GOVERNMENT OF INDIA  
MINISTRY OF ENVIRONMENT & FORESTS  
**Central Zoo Authority**

**Sub:- Construction of enclosures at Nagaland Zoological Park, Rangapahar.**

**Ref:- Your office letter No. FOR/WORKS-1/2001(Pt) dated 14.10.2011.**

The designs for the construction of enclosures for Great Indian hornbill, Barking deer, Hoolock gibbon, Fox, Common leopard, Stump tailed macaque, Burmese tortoise, Jungle cat and 2.5 km metalled by pass road at Nagaland Zoological Park, Rangapahar were placed before the Meeting of the Expert Group on Zoo Designing of the Central Zoo Authority held on 12<sup>th</sup> December, 2011. The observations of the committee are given below:-

NAGALAND ZOOLOGICAL PARK, RANGAPAHAR  
HOOLOCK GIBBON ENCLOSURE  
(ANIMAL HOUSE)

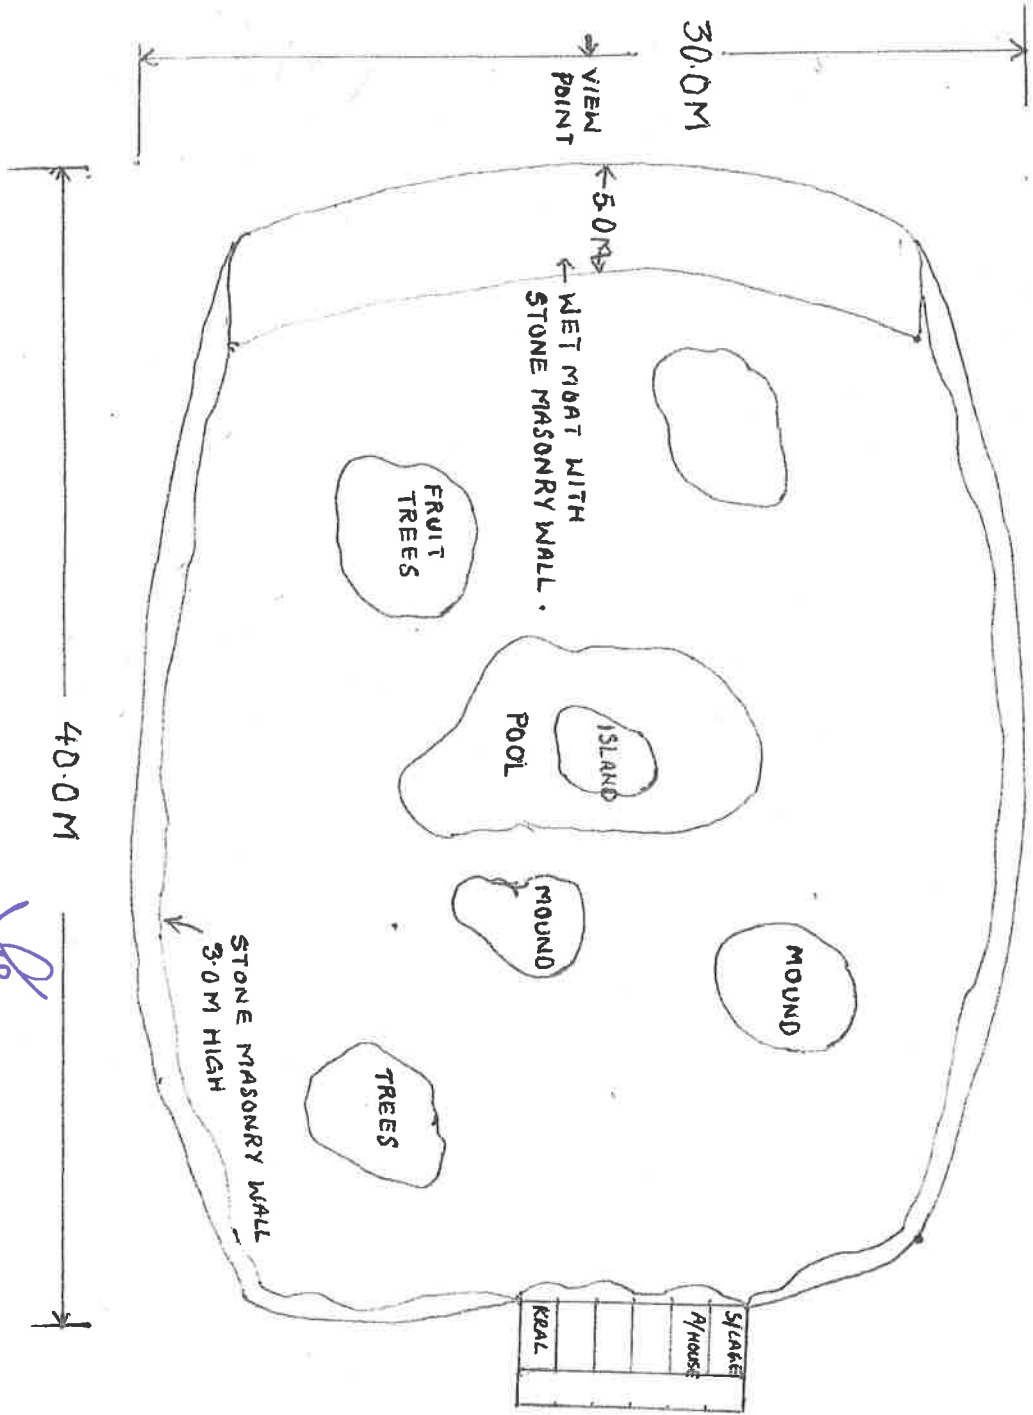
- (a) The width of the inclined sheet use as a barrier should not be less than 2.5 meter.
- (b) The D-4 should be located side wise and D-5 should be used as a lifting door.
- (c) The squeeze cage should be located inside attached with a cell and should be of small in size.
- (d) The kraal should be kept outside of the feeding and retiring cells and the kraal location should be interchanged with squeeze cage.

Keeping in view of the above, revised design should be submitted to the Central Zoo Authority for records. A copy of the design indicating the necessary amendments to made are enclosed herewith for your perusal.
